## Upgraded Gearcase Offering - Verado L6 Models

Models Covered	Serial Number Or Year
200/225/250/275/300 with 4.8 Inch Gearcase Torpedo	1B831023 and Below

46176

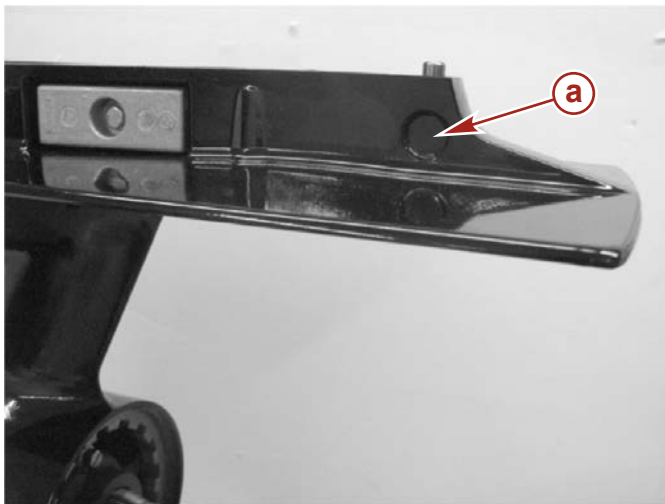
With the introduction of the new 5.44 inch Verado gearcase, Mercury Marine can provide its customers with an improved gearcase for world-class reliability, durability, corrosion resistance, performance, and versatility in all waters of the world. Mercury Marine would like to offer the new gearcase as an upgrade to our qualifying customers as follows.

**a -** Recessed circle (port side) identification mark for new gearcase with 5.44 inch torpedo

## Shift Shaft Alignment for 5.44 Inch Verado Gearcase Installation

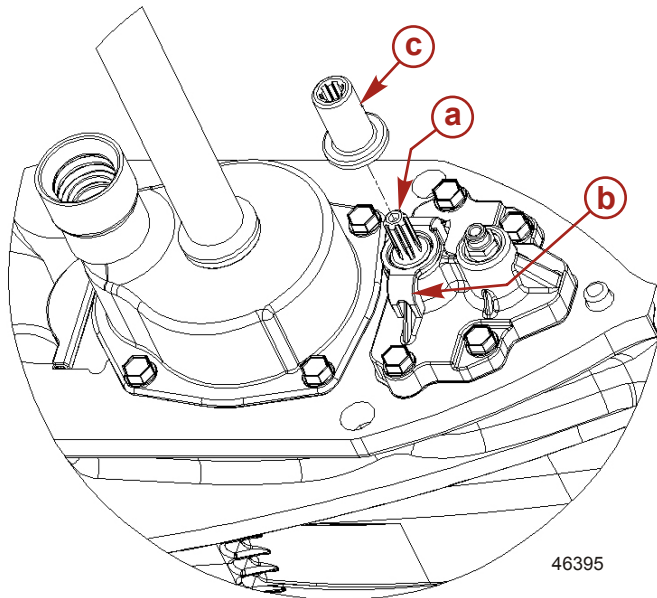
**IMPORTANT:** The 5.44 inch Verado gearcase is not equipped with a neutral detent. Use this information to supplement the current Verado service manual for gearcase installation.

1. While rotating the propeller shaft in either direction, turn the shift shaft counterclockwise to engage the sliding clutch fully into the gear. Note the position of the shift shaft.
2. Turn the shift shaft clockwise to allow the propeller shaft to turn freely. While rotating the propeller shaft, turn the shift shaft clockwise fully into gear. Note the position of the shift shaft.
3. Rotate the shift shaft counterclockwise to the center location of the noted gear engagements. This is the neutral position.
4. Rotate the propeller shaft to verify the neutral position. The propeller shaft will rotate freely in either direction.
5. Install the shift shaft retainer assembly.
6. Install the coupling onto the shift shaft.

- a - Shift shaft
- b - Retainer assembly
- c - Coupling
